City of Ketchum
Planning & Building

IN RE:)
)
 Warm Springs Ranch Residences Lot 35) **KETCHUM PLANNING & ZONING COMMISSION**
 Design Review) **FINDINGS OF FACT, CONCLUSIONS OF LAW, AND**
 Date: September 26, 2023) **DECISION**
)
 File Number: P23-020)

PROJECT: Warm Springs Ranch Residences Lot 35
 FILE NUMBER: P23-020
 APPLICATION TYPE: Design Review
 REPRESENTATIVE: John Shirley – Think Architecture (architect)
 PROPERTY OWNER: Brennan Holdings No. 300 LLC
 LOCATION: 190 Bald Mountain Road (Lot 35, Block 4, Warm Springs Ranch Residences)
 ZONING: General Residential – Low Density (GR-L)
 OVERLAY: None

GRADING & DRAINAGE PLAN
WARM SPRINGS RANCH LOT 35
T4N, R17E, SEC 12, B.M., BLAINE COUNTY, IDAHO
PREPARED FOR: MAGLEBY CONSTRUCTION

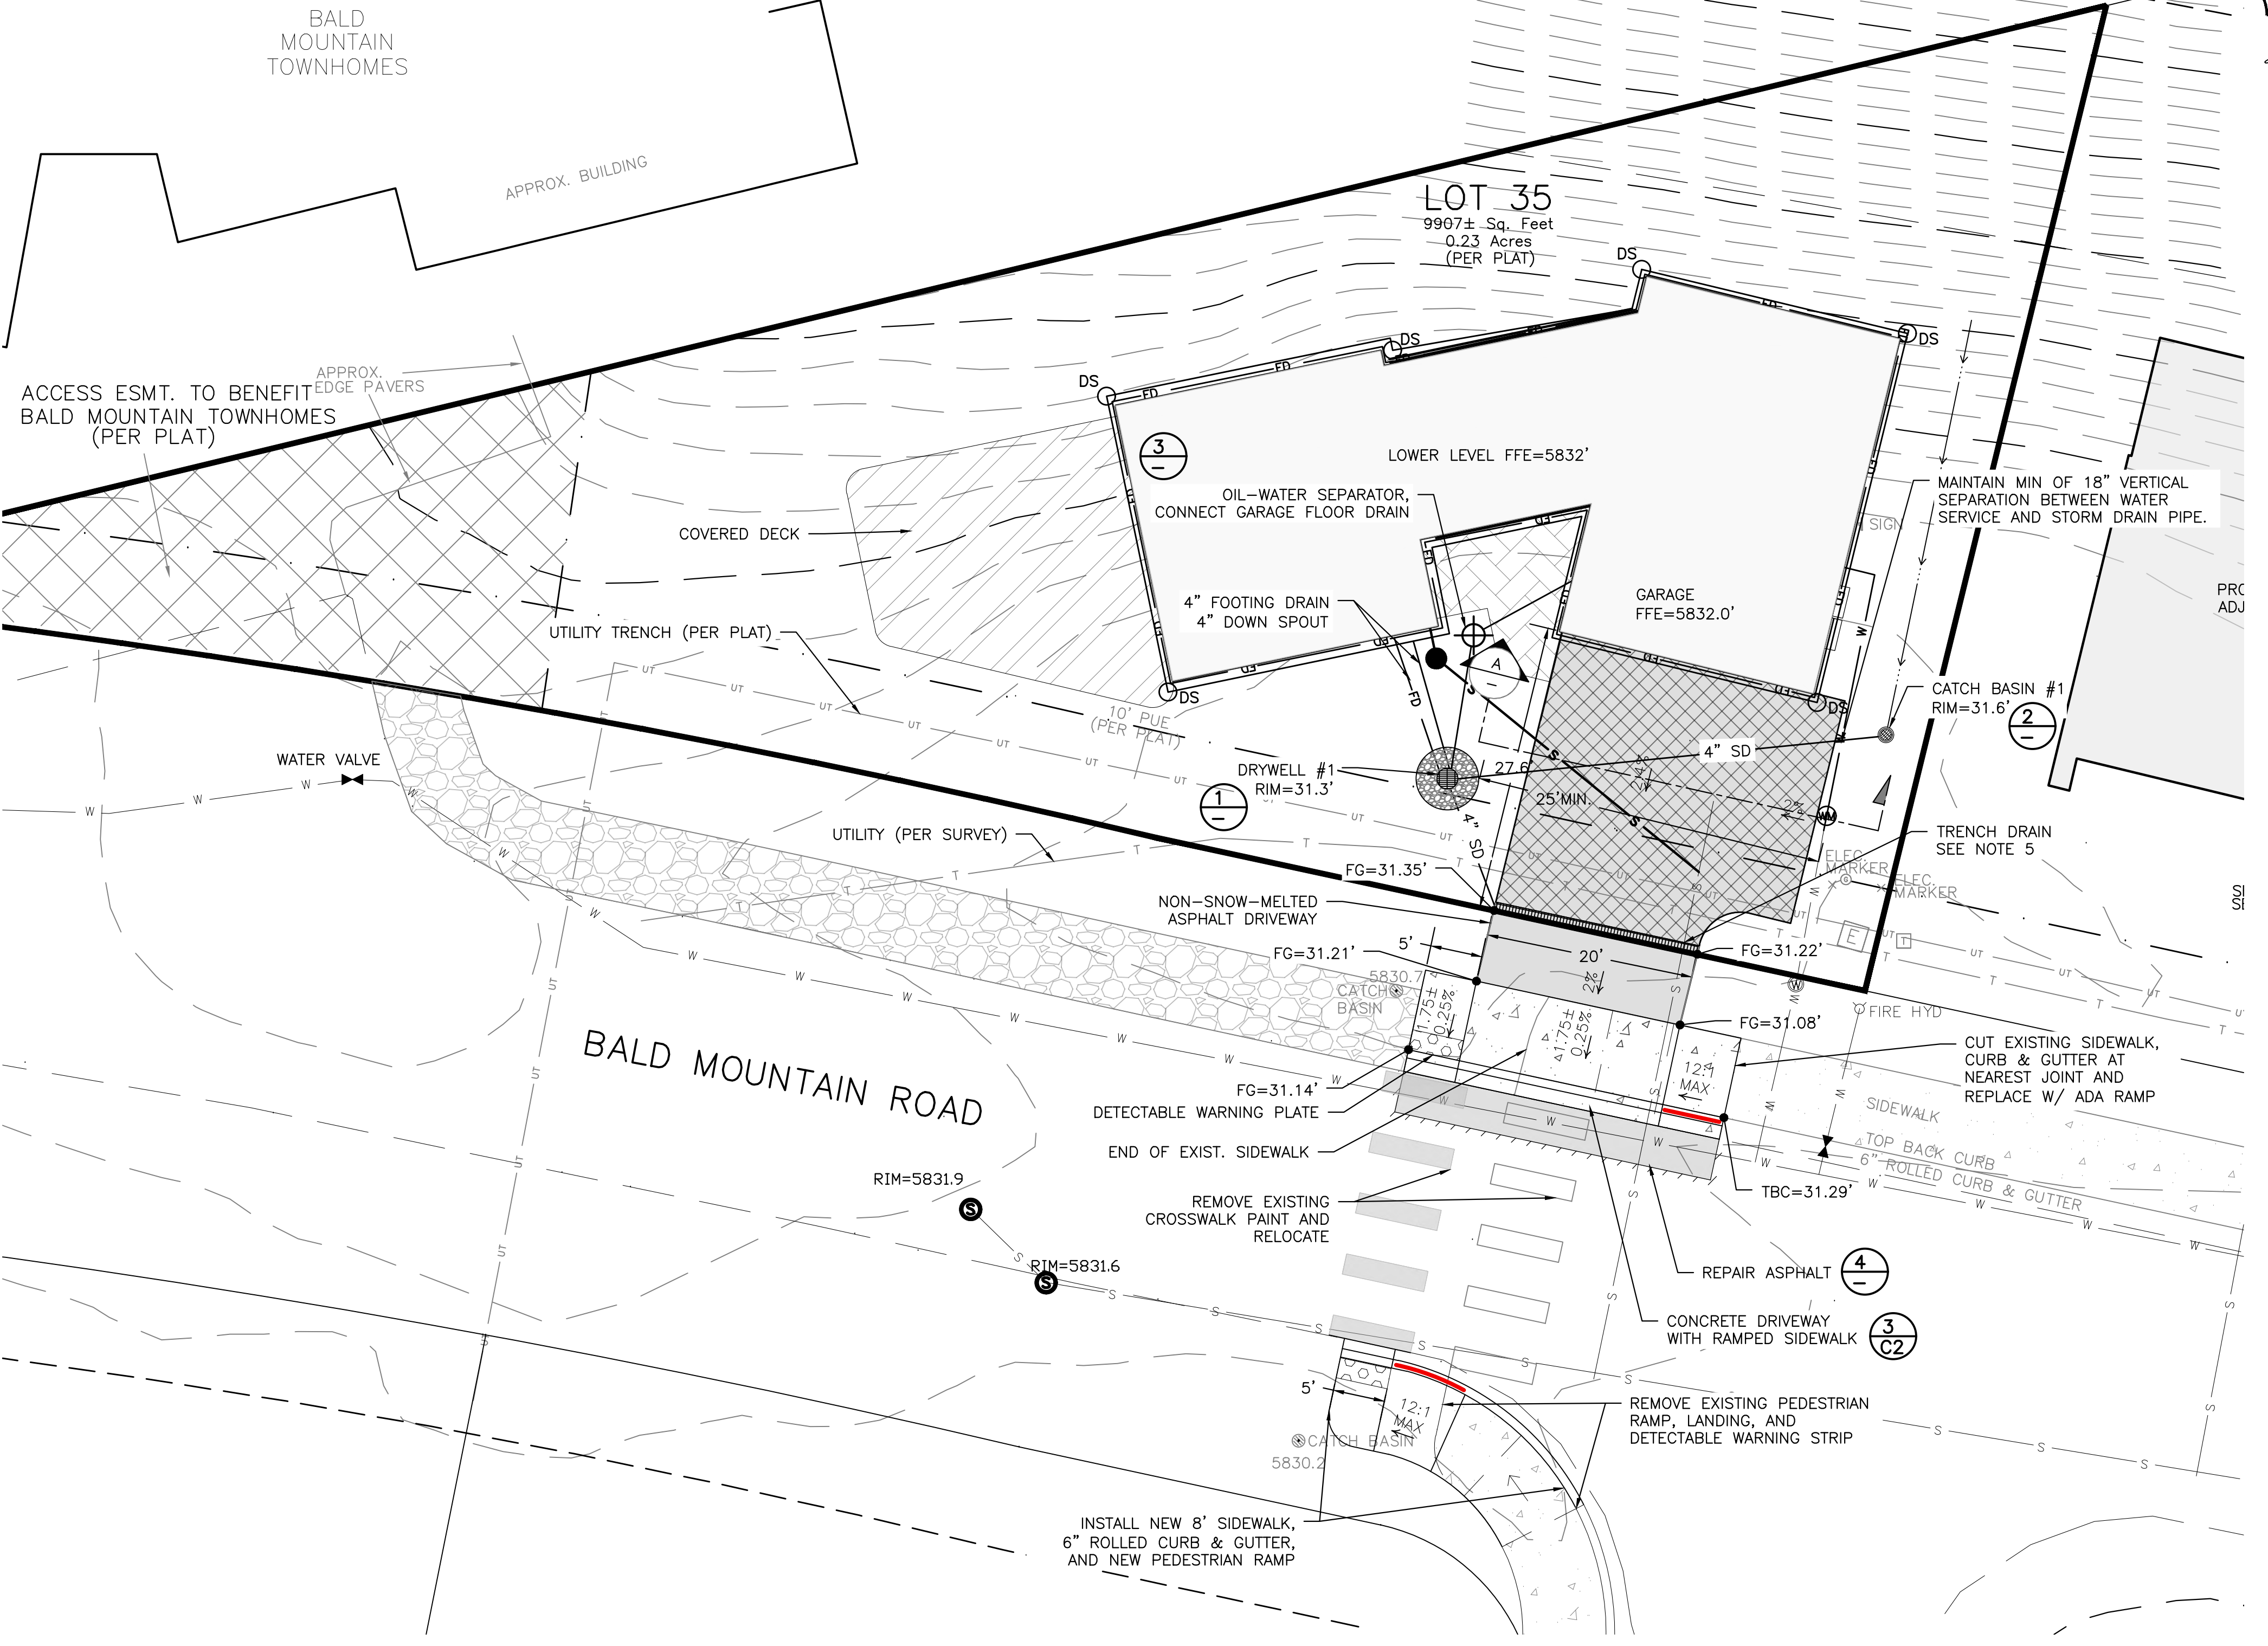
17.96.060.C.1 - Drainage	Conformance
<i>All stormwater shall be retained on site.</i>	YES
<p>Finding: Pursuant to KMC §17.96.060.C.1, all storm water drainage shall be retained on site. Drainage improvements are specified on Sheet C-1 of the project plans. The drainage improvements include the installation of a trench drain bordering the width of the driveway. A combination of drywells and catch basins will be installed to collect stormwater from the rest of the property. The City Engineer has reviewed the proposed drainage plan and believes the trench drain and drywell improvements are sufficient to maintain all storm water drainage on the subject property.</p>

Finding: Drainage improvements are specified on Sheet C-1 of the project plans. The drainage improvements include the installation of a trench drain bordering the width of the driveway. A combination of drywells and catch basins will be installed to collect stormwater from the rest of the property. The City Engineer has reviewed the proposed drainage plan and believes the trench drain and drywell improvements are sufficient to maintain all storm water drainage on the subject property.

Finding: The City Engineer has reviewed the proposed drainage plan and believes the trench drain and drywell/catch basin improvements are sufficient to maintain storm water drainage on the subject property. The City Engineer may require additional drainage improvements if necessary. If approved, the applicant shall submit final civil drawings for all drainage improvements with the building permit application to be verified, reviewed, and approved by the City Engineer and Streets Department.

Finding: The drainage improvements include the installation of a trench drain bordering the width of the driveway along Bald Mountain Road. A combination of drywells and catch basins will be installed to collect stormwater from the rest of the property. The City Engineer has reviewed the proposed drainage plan and believes the proposed trench drain and drywell improvements meet city standards.

All drainage plans and specifications shall be reviewed and approved by the City Engineer and Streets Department prior to issuance of a Building Permit.

All drainage plans and specifications shall be reviewed and approved by the City Engineer and Streets Department prior to issuance of a Building Permit.

Sheet No:
L3

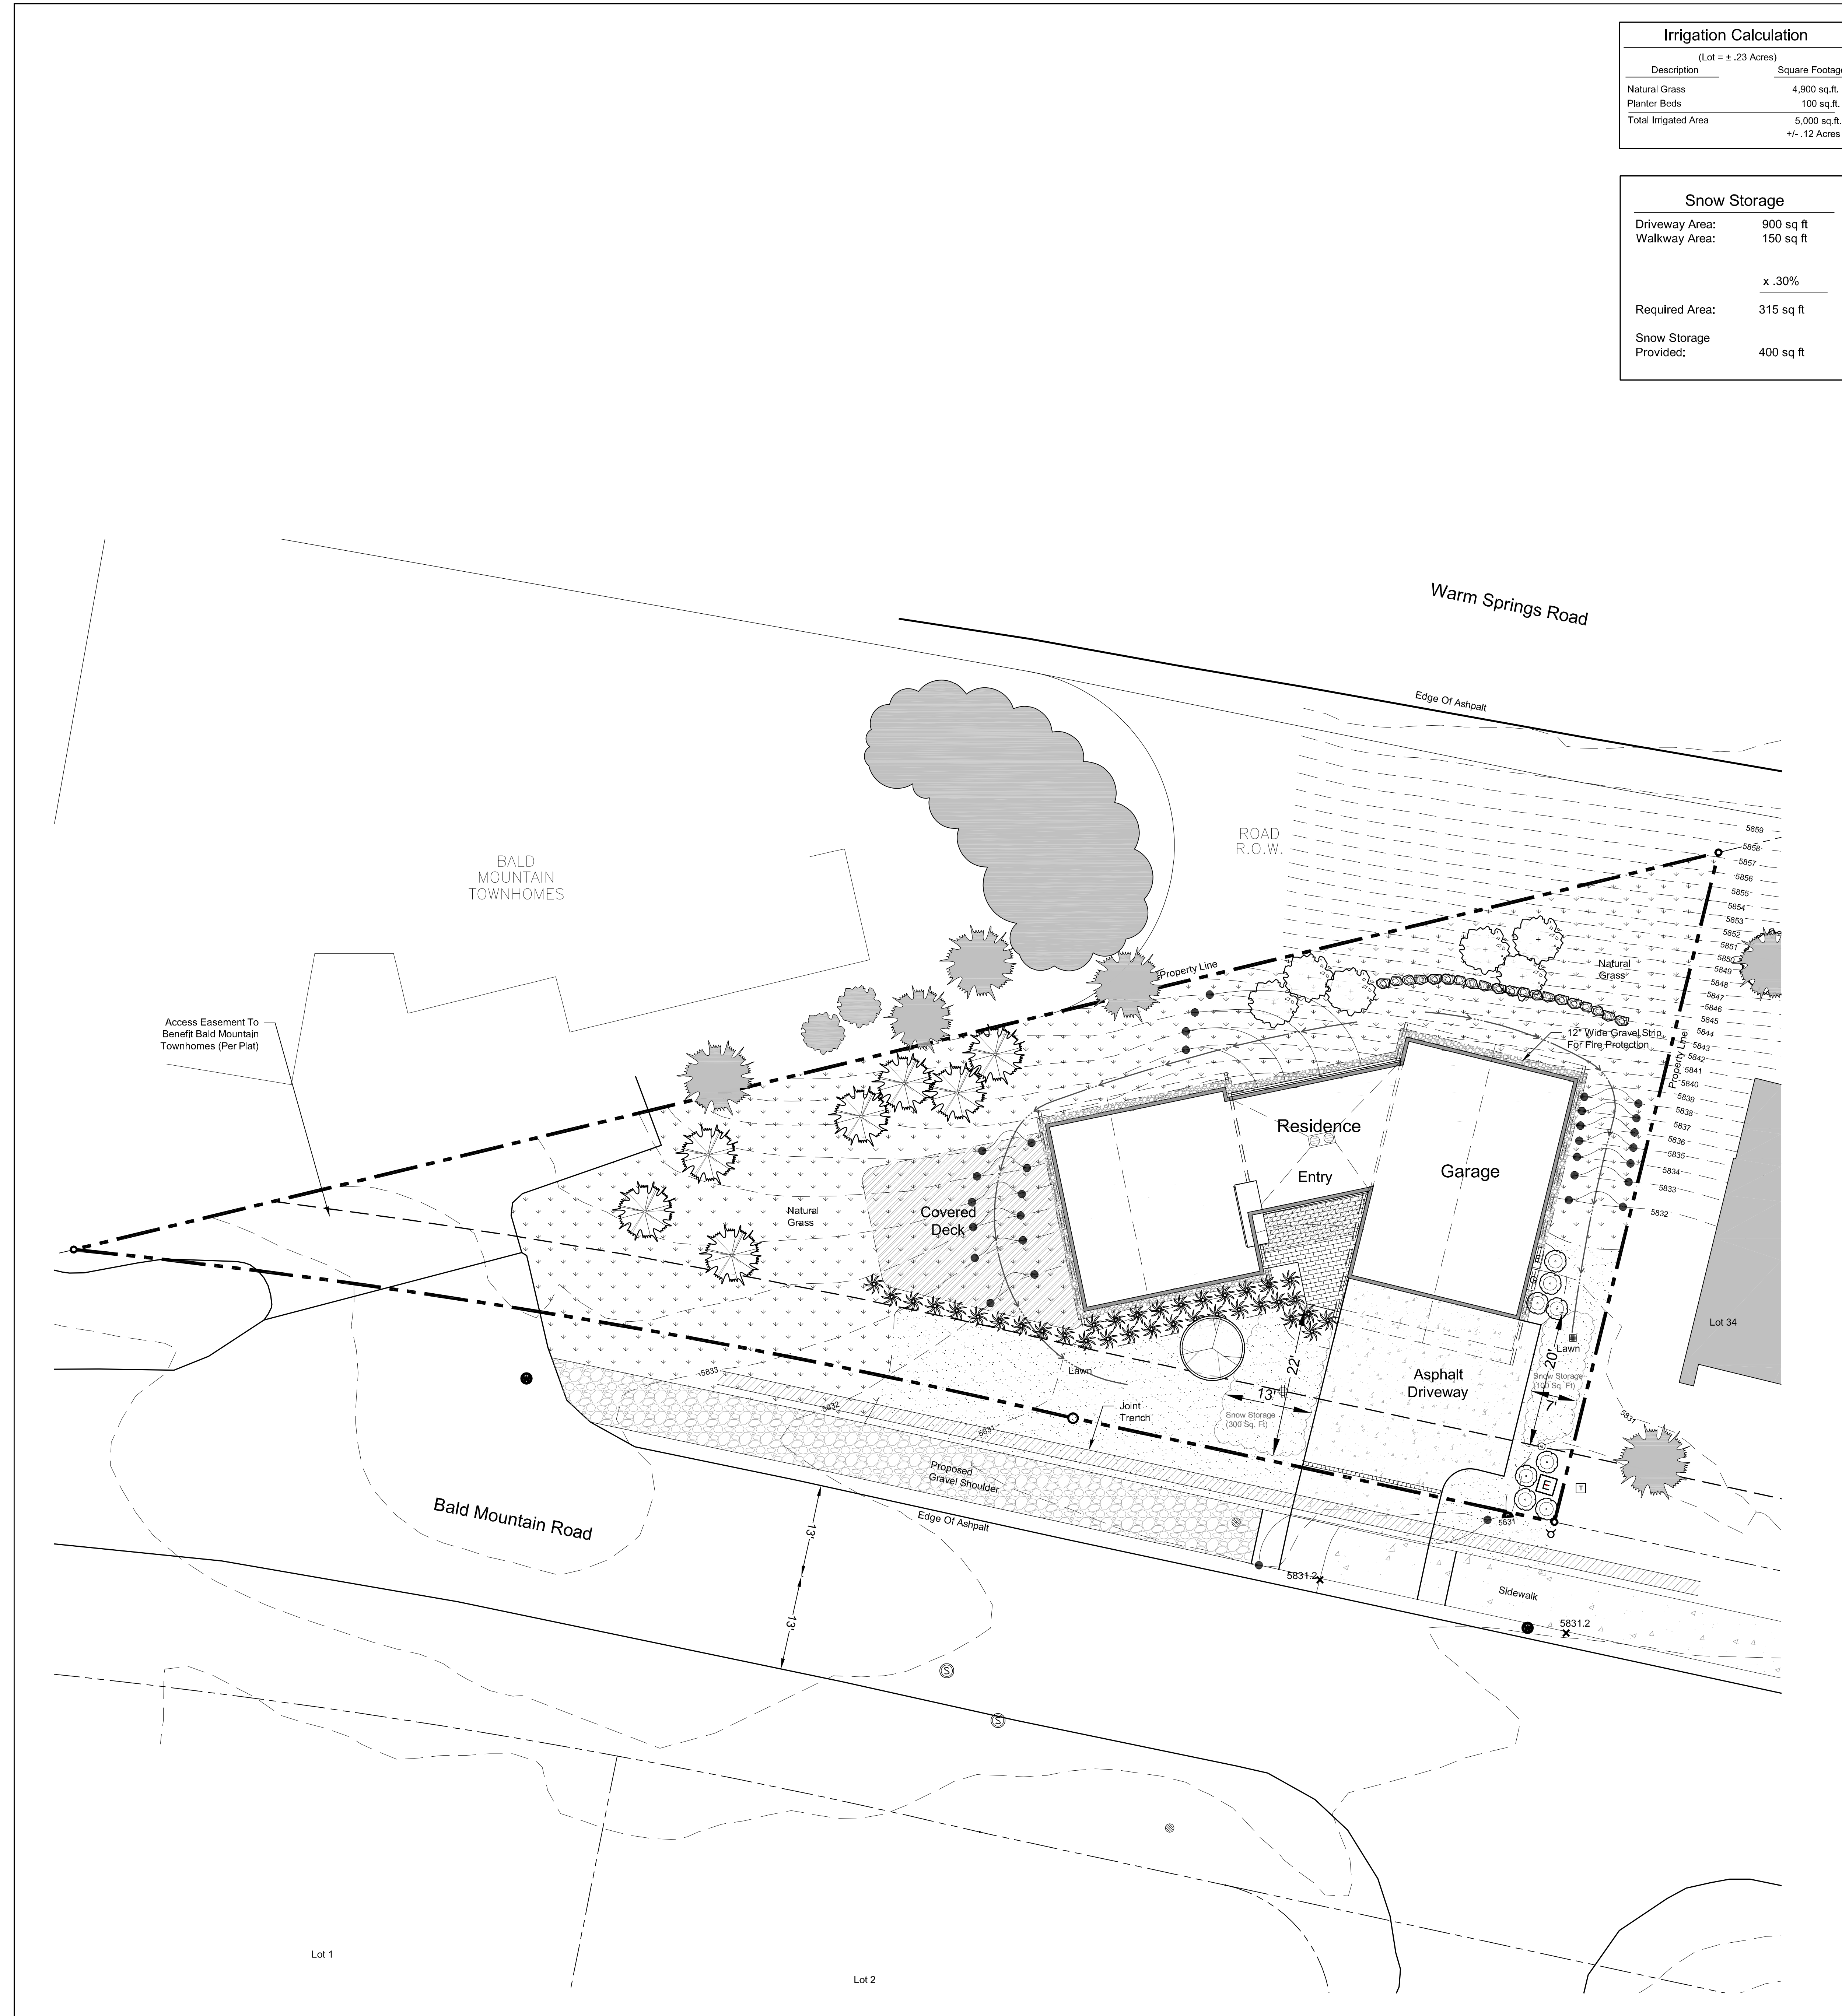
17.96.060.H.1 – Snow Storage	Conformance
<i>Snow storage areas shall not be less than 30 percent of the improved parking and pedestrian circulation areas.</i>	YES
Finding: Sheet L3 of the project plans indicate the proposed snow storage areas to include a total of 400 square feet, greater than the required 30% (1,050 * .30 = 315 square feet).

17.96.060.H.2 – Snow Storage	Conformance
<i>Snow storage areas shall be provided on site.</i>	YES
Finding: Locations of snow storage areas are indicated on Sheet L3 of the project plans.

17.96.060.I.1 – Landscaping	Conformance
<i>Landscaping is required for all projects.</i>	YES
Finding: Landscaping has been provided for the project as indicated on Sheets L3 of the project plans.
